#### **Declaration of David Lochbaum**

- 1.2 I have been retained by a group of environmental organizations to assist in the preparation of comments invited by the U.S. Nuclear Regulatory Commission (NRC), on its Draft Generic Environmental Impact Statement on the Waste Confidence Decision (WC DGEIS).

- 1.3 The purpose of my declaration is to address the adequacy of the discussion of spent fuel pool leak risks in the WC DGEIS to support the NRC's proposed finding in 10 CFR. § 51.23(a)(2) that it is feasible to safely store spent nuclear fuel in spent fuel pools after nuclear power reactors permanently cease operation.

4.11 The following two panels from Figure 1 of the GAO report highlight events occurring between the initial detection of radioactively contaminated water (i.e., tritium) in the soil around BNL and the ultimate discovery of leakage from the spent fuel pool more than a decade later.

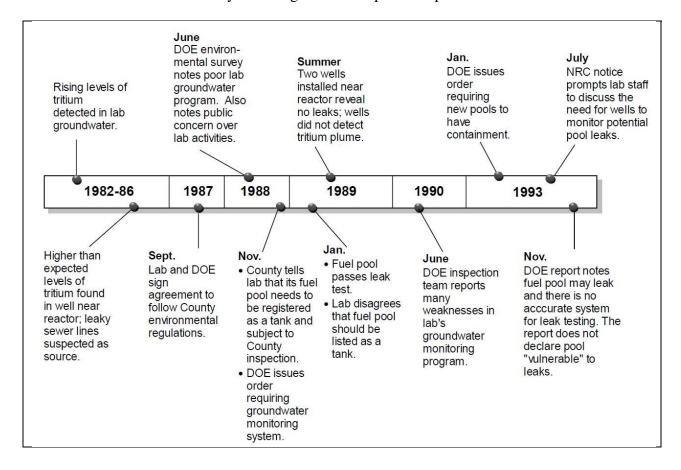
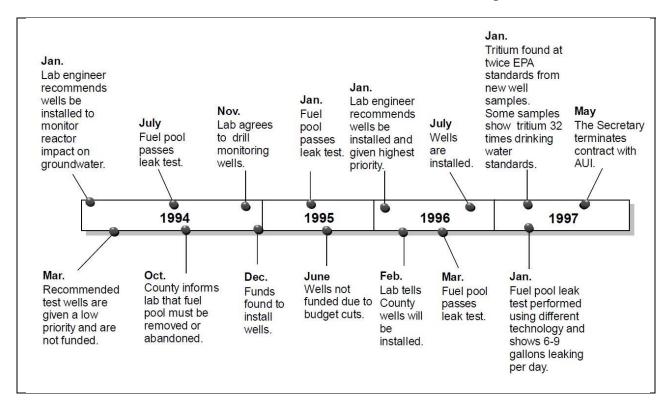
4.10 That the BNL leak remained undiscovered for over a decade clearly illustrates that detection of radioactively contaminated water in monitoring wells or the surrounding soil does not necessarily lead to finding a leaking spent fuel pool. According to the GAO's report:

BNL officials also relied on well-sampling results to reinforce their position that the spent-fuel pool was not leaking, but these samples did not provide adequate coverage of the area surrounding the reactor where the spent-fuel pool was located. (GAO 1997, page 10)

4.17 If the BNL spent fuel pool leaked at 6 to 9 gallons per day for 12 years, then 26,280 to 39,420 gallons of radioactively contaminated water reached the ground before being detected and terminated. This longstanding leak is an important example that NRC should have considered in the WC DGEIS. The WC DGEIS must explicitly identify the regulatory requirements that remain in place during the 60-year short-term storage period that provide reasonable assurance that future leaks similar to the BNL spent fuel pool leak—or worse—cannot result in significant impacts.

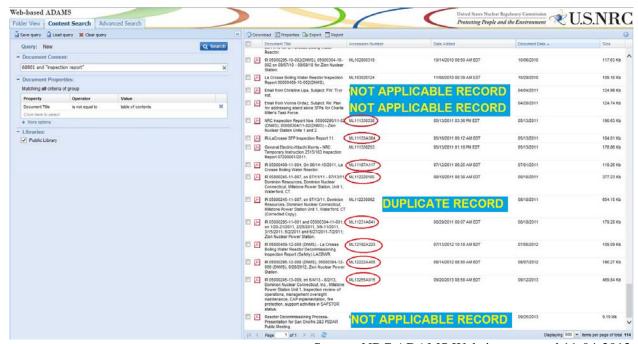
- 7.31 The NRC inspection effort at Dresden is not unique. Shown above are the NRC inspection hours applied to various reactors in 1992. The Three Mile Island nuclear plant had one operating reactor and one permanently shut down reactor. Its Unit 1 reactor received nearly 3,700 inspection-hours of NRC attention while the permanently shut down Unit 2 reactor received about one-tenth of that attention, a scant 300 inspection-hours or so. In 1992, the Unit 1 reactor at the Browns Ferry nuclear plant had been shut down since March 1985 not permanently shut down, but not expected to restart anytime soon (it did not resume operating until early 2007). NRC inspectors devoted less than 750 hours of attention to it during 1992. The permanently shut down Unit 1 reactor at Dresden was not even on the NRC's charts: the Dresden Units 2 and 3 reactors received over 3,000 NRC inspection-hours.

Figure 2-4. Continued Storage Timeline

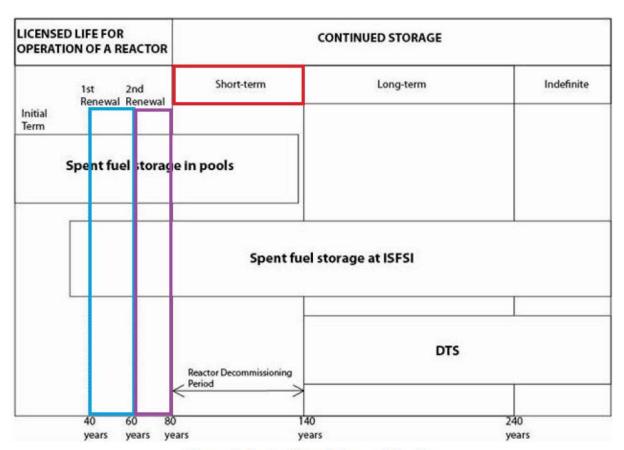
7.39 But the period of extended operation only covers the duration of reactor operation, not to the end of the 60-year short-term storage period as clearly illustrated in Figure 2.4 of the WC DGEIS:

7.40 The applicant for a renewed operating license develops aging management programs for inscope systems, structures, and components—including the spent fuel pool and associated equipment—that provide reasonable assurance that required margins will be maintained over the duration of extended reactor operation. Once the period of extended operation ends and the short-term storage period begins, no regulations require licensees to continue their aging management programs.

- 7.41 The short-term storage period of 60 years equals the operating lifetime of a nuclear power reactor obtaining only one renewal the 40-year initial term plus the 20-year period of extended operation. The aging management programs prepared by the applicants and approved by the NRC only consider the 20-year period of extended operation. While the efficacy of these programs does not automatically expire along with the operating licenses, the fact remains that neither the plant owners nor the NRC have formally evaluated aging degradation mechanisms and reliable barriers against excessive degradation over the 60-year short-term storage period assumed in the WC DGEIS.
